HOWARD COUNTY HISTORIC PRESERVATION COMMISSION  
*ELlicott City HISTORIC DISTRICT ■ LAWYERS HILL HISTORIC DISTRICT*  
3430 Court House Drive ■ Ellicott City, Maryland 21043

## March Minutes

Thursday, March 3, 2022; 7:00 p.m.

Figure 5 - Proposed site development plan

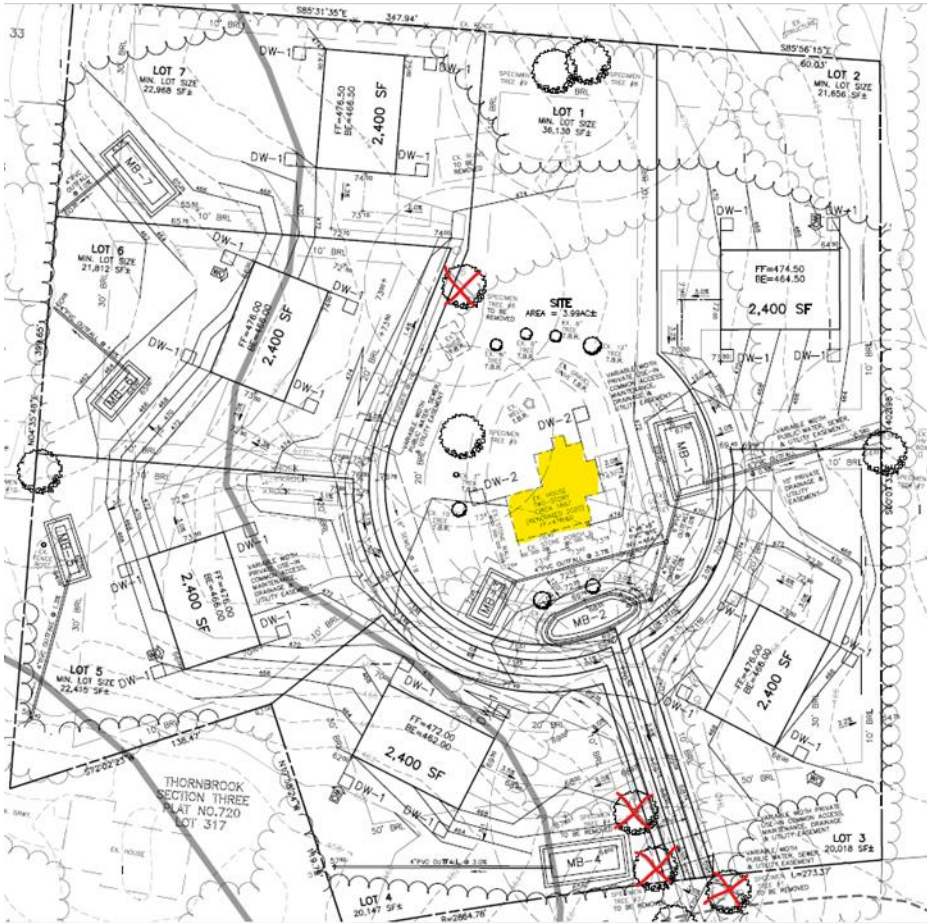
The site development plan shows that several specimen trees are proposed for removal at and along the existing historic driveway (which appears will remain as the new drive until the loop is created).

Ms. Danna asked them to explain what a micro bioretention was. Mr. Lomangino said water from downspouts and such will be channeled to a small bioretention pond. The retention will be filled with media that can filter the water. Ms. Danna asked what they would look like. Mr. Lomangino said it will appear to be a landscaping feature, with mulch and plants. He said it would have a ponding depth, a slightly sunken landscape. Ms. Danna said her only comment is that all drainage areas, such as three on Lot 1 alone, detract from the look of the house because they are located in front of the house. Mr. Riedel said that MB2 will be located in the circular driveway and needs to be there to collect rain from the driveways due to the grading. Ms. Danna expressed concern with the location of the micro bio-retention. Mr. Lomangino said the grade is going away from the house and it will appear to be a landscape area with native plants like inkberry. He said the intent was to get water away from the historic house. He explained the goal was to capture the water so it remains on site and does not run off on other properties. He said it would look like any other landscape bed out front of the house. Mr. Lomangino asked what she thought would be less unsightly. He explained that otherwise he would have to put in a culvert. Ms. Danna thought the bio-retention could be on the side of the road. Mr. Lomangino pointed out the driveway that ran in front of the house off of the road and explained he would need to take the stormwater away from that impervious surface and away from the house. Ms. Danna asked if they were adding the driveway to the front of the house. Mr. Lomangino said they were adding the driveway. Ms. Danna thought the driveway should be located around the rear of the house.

Ms. Flynn Giles said the loop driveway was an enhancement and an appropriate location for a house like this. She found the micro bio-retention was an enhancement as well and did not find that it detracted from the historic structure. Mr. Lomangino said the other nice feature about having the stormwater there is that they are mandated to maintain it and routinely inspect it to make sure it is functioning as designed. Ms. Flynn Giles found the plan to be a good way to preserve the historic structure as stormwater was only required due to the other activities happening and otherwise there would be no management.

Mr. Reich said the plan was fantastic and thanked them for making the house the center of the development. He said it was a great example of how to build a small subdivision. Mr. Reich liked the circular driveway and found it was a great design. Mr. Reich said it looked like a 16-foot driveway from the road. He asked if the stone gate posts will be saved from Route 99. Mr. Riedel said they cannot save the gate posts. Mr. Reich suggested moving them back to be part of the subdivision entry. He said it was a shame the house was modernized and described it as a cross between 1897 and something out of modernist architecture, but was glad the house was still there. He said it appeared the landscape around the house was being retained, such as the trees right around the house. Mr. Reidel said they saving as much as they can but explained there are large trees along the driveway that need to come out and that some of them are in really bad shape. Mr. Reich said the grading looked to be only 6 to 8 feet from the existing grade, which was not bad. Mr. Reich also said it looked like they gave the historic house the maximum buffer possible between it and the new houses.

Ms. Zoren agreed with most of the previous Commissioners comments. She initially had concern with bio retention in front of the house, but agreed that it did appear that it could be adjusted. She has seen them done well and a landscaping bed as a focal feature would be good. She agreed with saving the gate posts and using them elsewhere on site, such as on the circular drive of the existing house, said that it would be a benefit for this site. Mr. Lomangino said that she and Mr. Reich made interesting points about the gateposts and he had not thought of repurposing them, but thought they could adorn the entrance size as an homage to the historic building.

**Figure 8 - Proposed walkway material, concrete gray variegated Nantucket Paver, Traditional Yorkstone.**

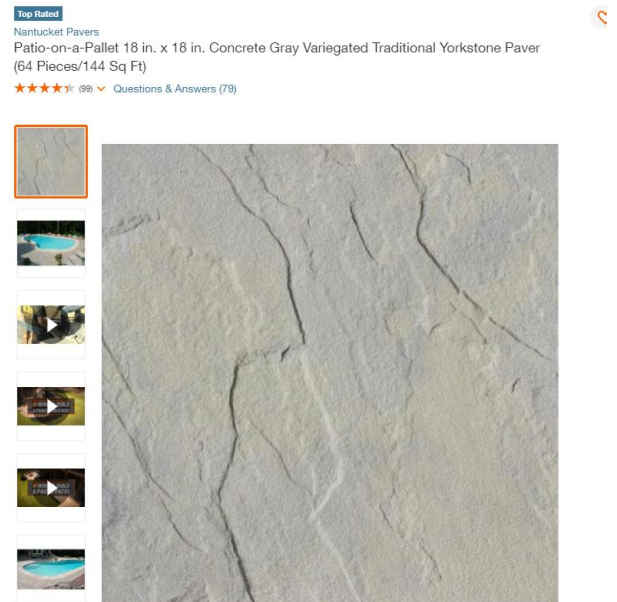
The proposed concrete pavers resemble stone in their size, color and texture and comply with the Guideline recommendations to look like indigenous stone. The pavers are also compatible with the new retaining wall (HPC-22-03), the existing stone retaining wall and as a result, comply with the recommendations to be compatible with the setting and nearby historic structures.

Figure 12 - Proposed porch sign.

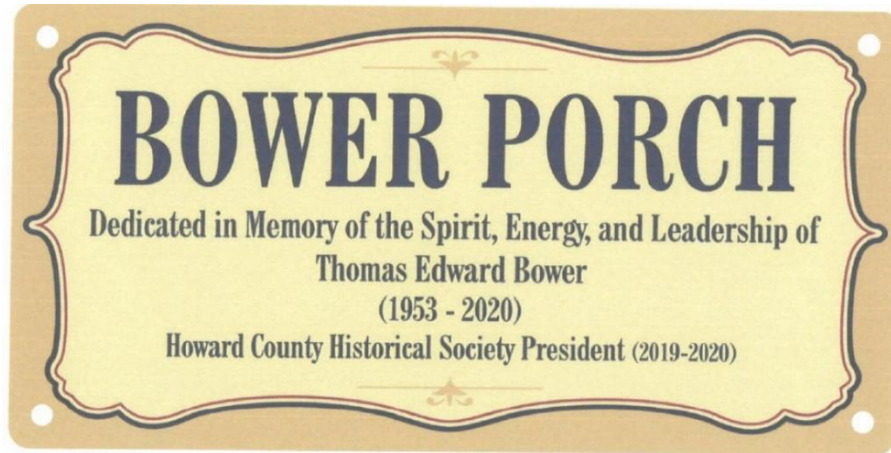
The Commission should determine if the sign complies with these Guidelines. While the text contains more verbiage than typical, it is not a business sign and is part of the museum signage. Likewise, while the sign is not wood or HDU to resemble wood, the aluminum material is appropriate for the angled freestanding sign and will not be overly bulky. The porch sign, also proposed to be aluminum, will sit flush against the fascia and not unnecessarily protrude due to the slim depth of the aluminum.

The porch sign will be 0.34 square feet and the garden sign 0.55 square feet. Each sign is well under the recommended size for its type.

Figure 21 - Updated site plan. Location of fence shown in yellow highlight.

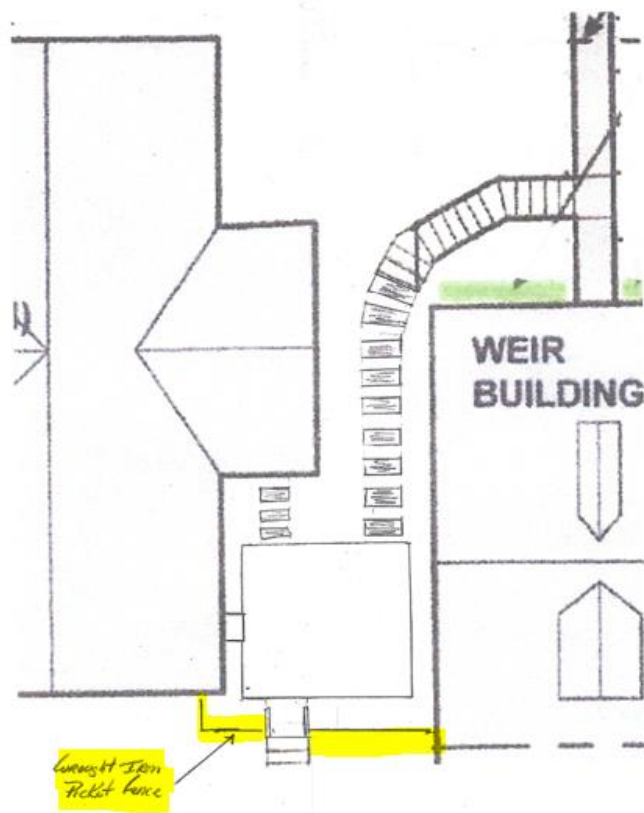
The proposed black iron fence complies with the Guideline recommendations and will be compatible with the iron fence on the existing historic structure.

Figure 22 - Updated patio detail.

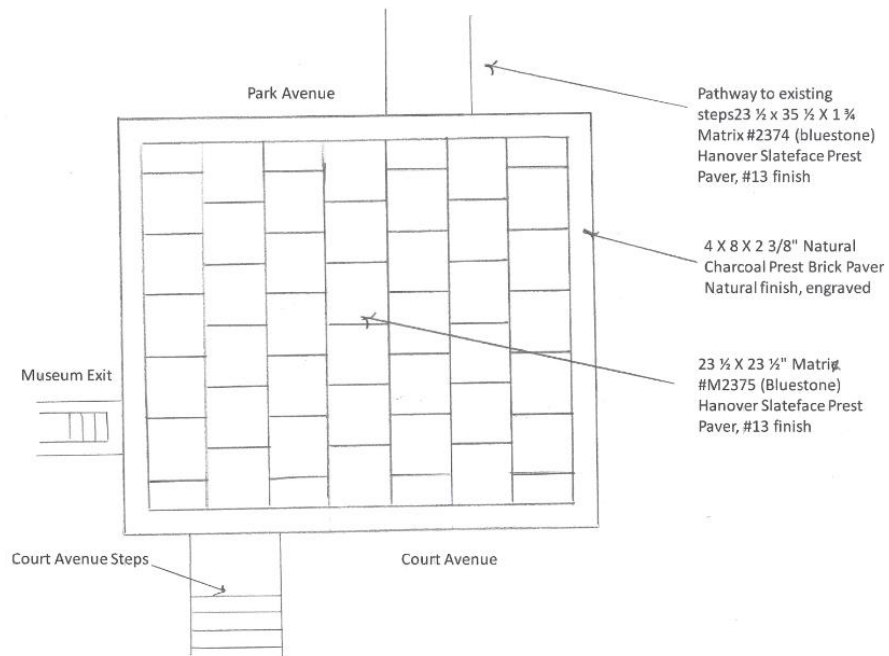
The Applicant originally proposed to use the Prest Brick concrete pavers, in the color Natural/Charcoal blend. When used next to a historic granite building, these pavers tend to look more like the concrete product they are, rather than a stone/brick product they are trying to emulate. The Applicant updated the proposal to include a concrete bluestone paver patio edged in the concrete paver, to unite the proposed flagstone pathway and proposed patio. The proposal complies with the Guideline recommendations.

**Testimony:** Ms. Flynn Giles was still recused and Mr. Tolen was already sworn in. Mr. Reich asked why they would not use real brick and bluestone pavers. Mr. Tolen said the brick cannot withstand the freeze cycle. Mr. Reich asked if he was saying the concrete pavers will withstand better than regular brick. Mr. Tolen said that was correct. Mr. Reich asked staff for advice on the Guideline recommendations for the concrete product. Ms. Holmes referenced Chapter 9.D where the Guidelines recommend using brick, stone or concrete pavers designed to look like indigenous stone.

Ms. Danna asked if the tone of the stairs will match the other materials they are requesting to use. Mr. Tolen said it will match the color of the steps from Park Avenue. Mr. Tolen said they were sandwiched between two stone buildings and were trying to play off of those colors. Ms. Danna suggested leaving the edging off of the patio. Mr. Tolen said the bricks were going to be the fundraiser to pay for the patio. Ms. Danna asked how the engraving would look. Mr. Tolen said it would be laser or sandblasted in. Ms. Danna asked if the brick will match the steps. Mr. Tolen corrected that the bluestone pavers will match the steps.
